# PRELIMINARY ENGINEERING REPORT ADDENDUM NO. 03

## KIAWAH RIVER WWTP MBR UNITS ADDITION

J-25328.0006

Prepared for  
**KIAWAH RIVER UTILITY COMPANY (KRUC)**  
May 2024

**Figure 4-1: Process Flow Diagram**

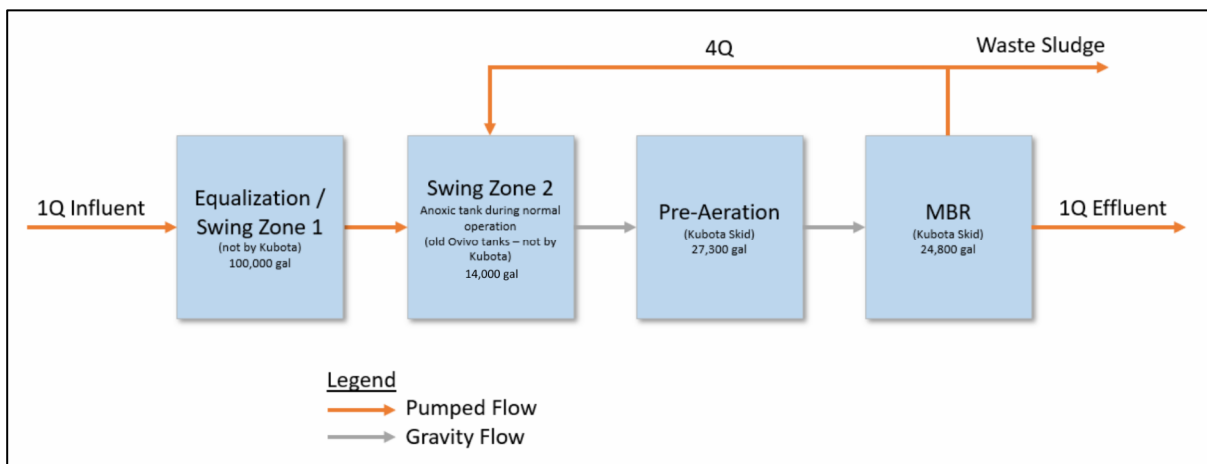
The existing Phase 1 plant includes one modular Ovivo MicroBLOX MBR treatment unit containing tankage for an anoxic basin and three MBR basins. The proposed project includes the addition of two new Kubota MBR treatment units. Each unit contains a pre-aeration zone, MBR zone and an enclosed equipment room.

Swing Zone 1: The EQ tank currently under construction is a 100,000-gallon storage tank. The EQ tank can be operated both aerobically, or anoxically by turning off the air and using jet mixing.

Swing Zone 2: Once the new Kubota MBR treatment units are operational, the existing membrane unit will be removed from the Ovivo MicroBLOX MBR basins, and the tankage will be converted to a mixed anoxic tank (swing zone).

Upon completion of the project, the treatment capacity of the Kiawah River WWTP will be 129,000 gpd. A straightforward process flow diagram is shown in Figure 4-1 below.

The Process Flow Diagram shown on Exhibit B illustrates the flow diagram for the entire treatment process. The existing Ovivo MicroBLOX MBR tankage will be converted and used as full anoxic zone treatment. New top mounted propeller mixers (such as Fusion FG-2M-1.0-70) will be added to each basin within the Ovivo train to function as anoxic.

The proposed project includes the installation of two different MBR system skids, with each skid containing one pre-aeration zone, one swing zone, one MBR zone, and one equipment room.

The existing MBR tanks at the facility will be re-worked to be converted into mixed anoxic tank volume. Based on the tank size estimate (14,000 gallons total) and biological design, this volume will be sufficient for current system flows and design loadings (excluding the flows listed for the optional adder third train).

**OVERALL SITE PLAN – WWTP**

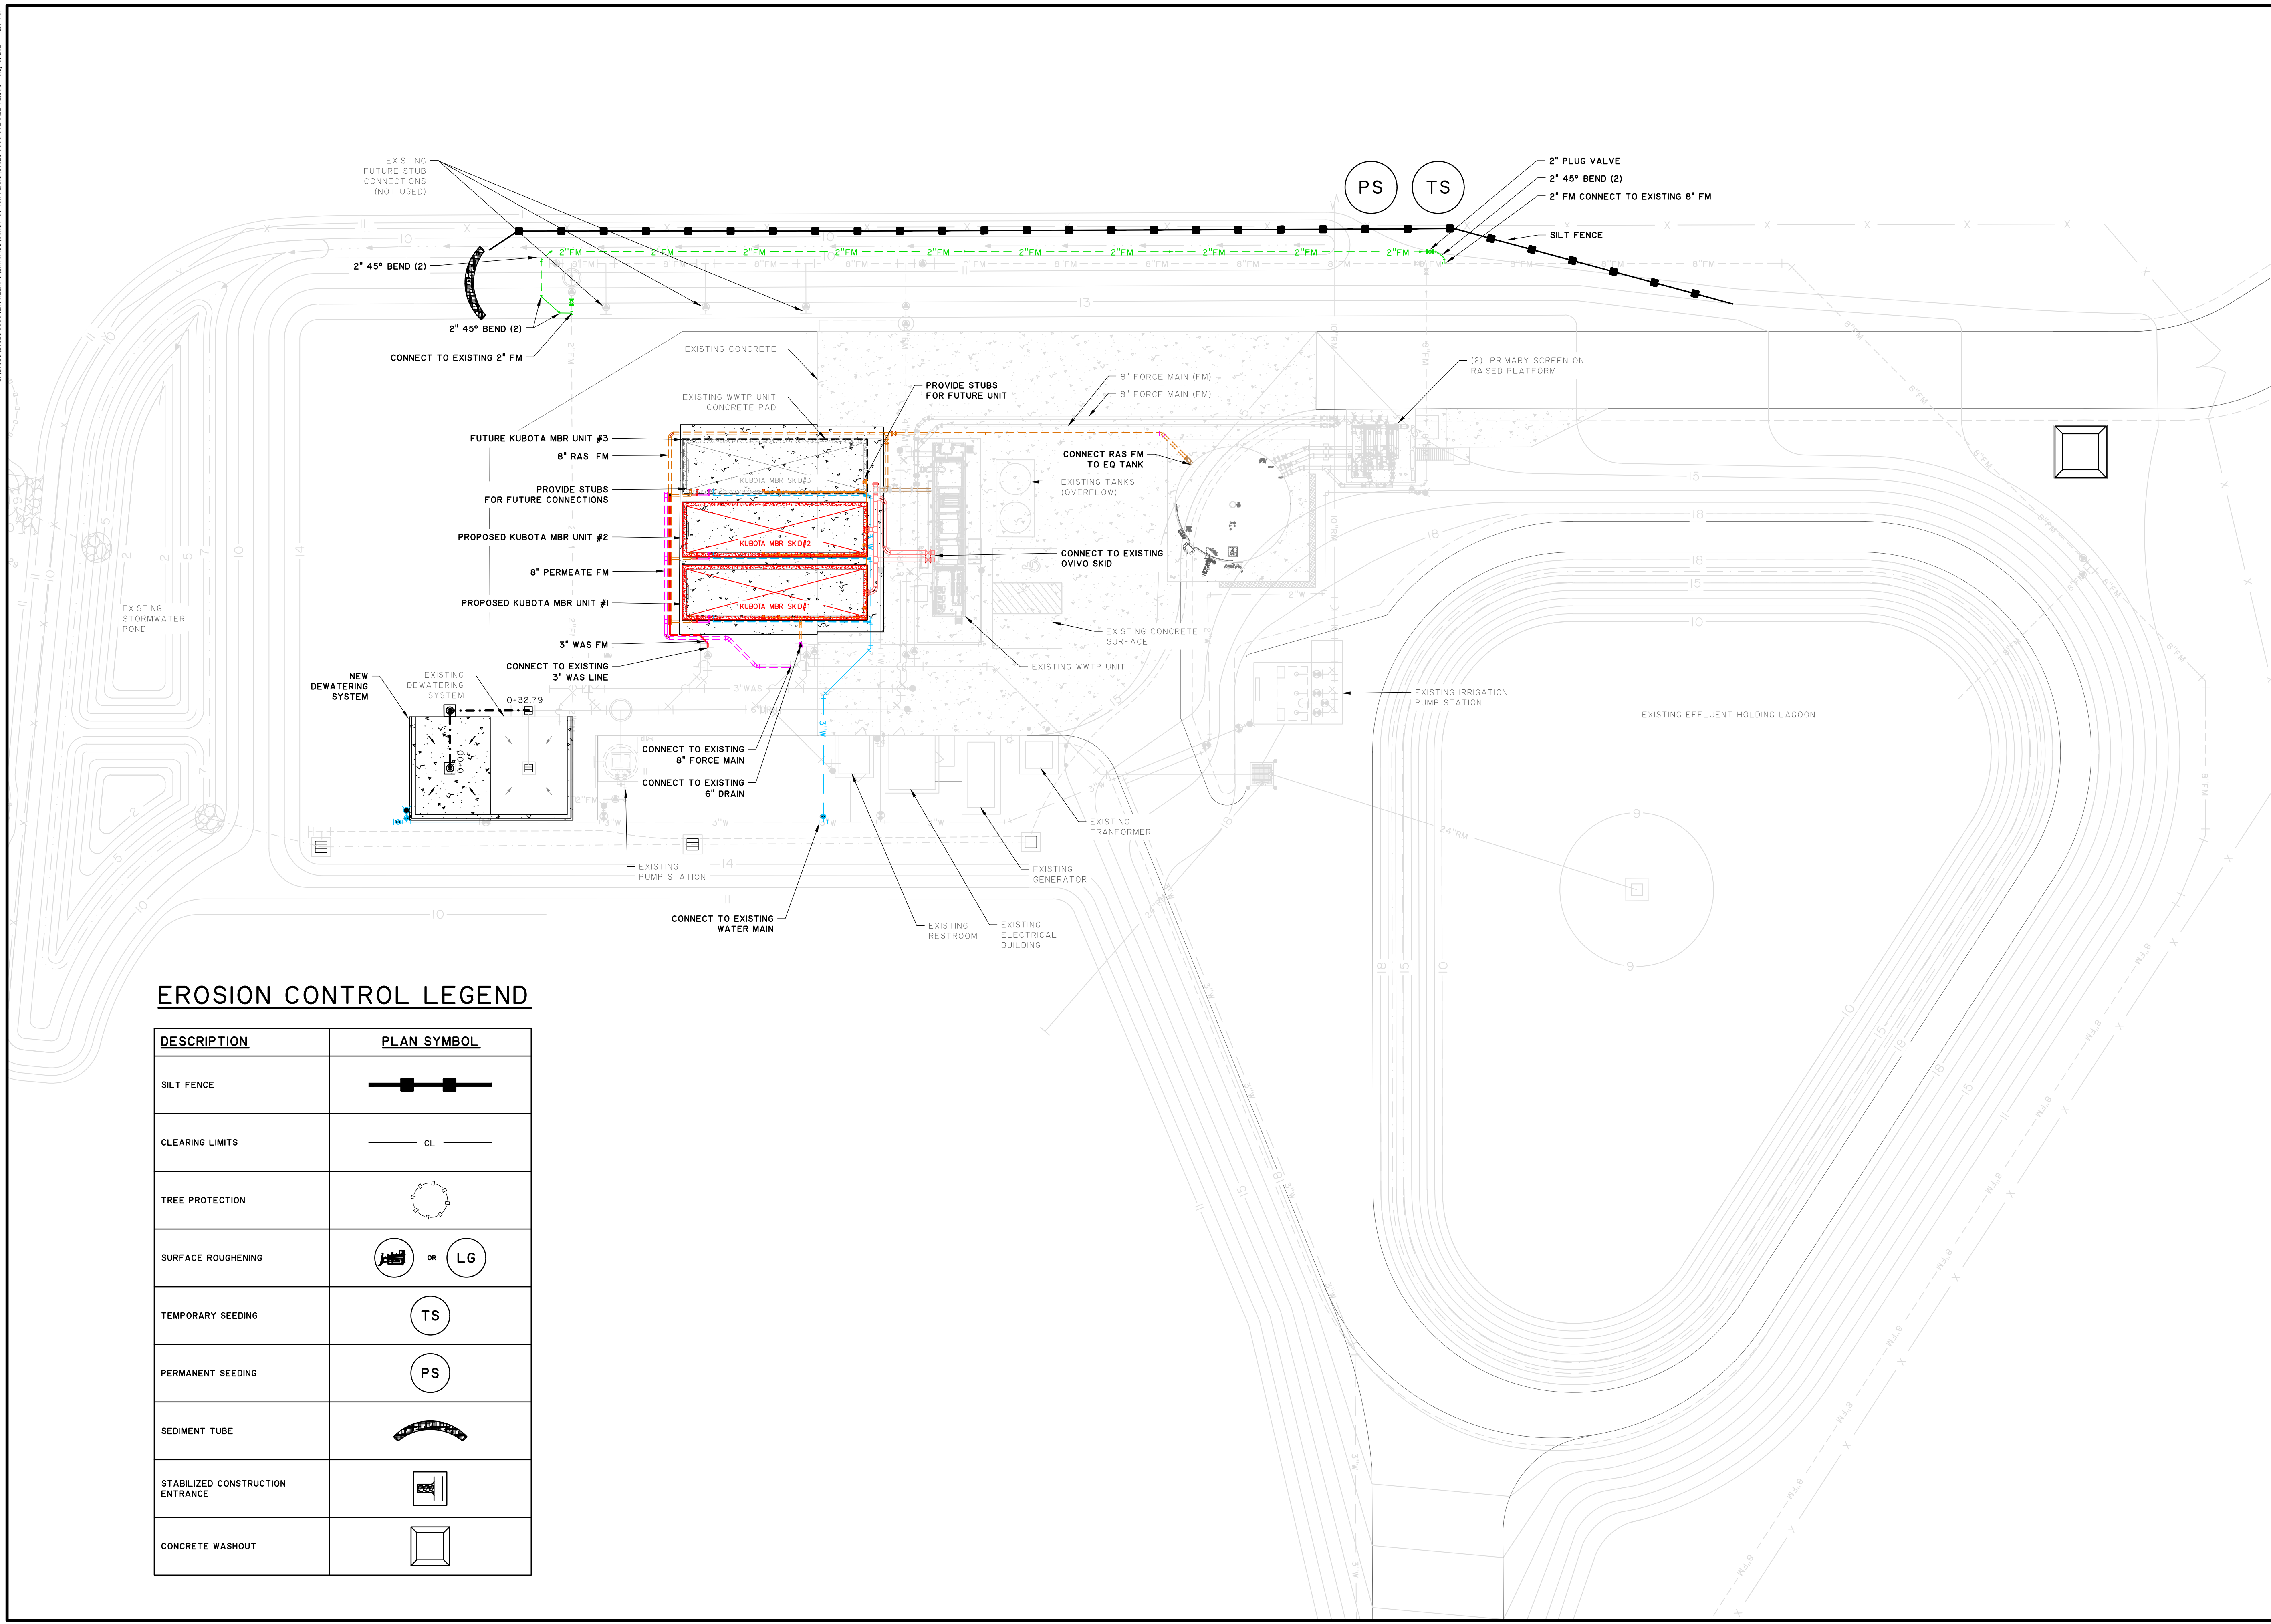
Exhibit A, Overall Site Plan-WWTP, shows the proposed modifications, including the location of two new Kubota MBR skids as integrated into the existing plant and the new EQ tank currently underway.
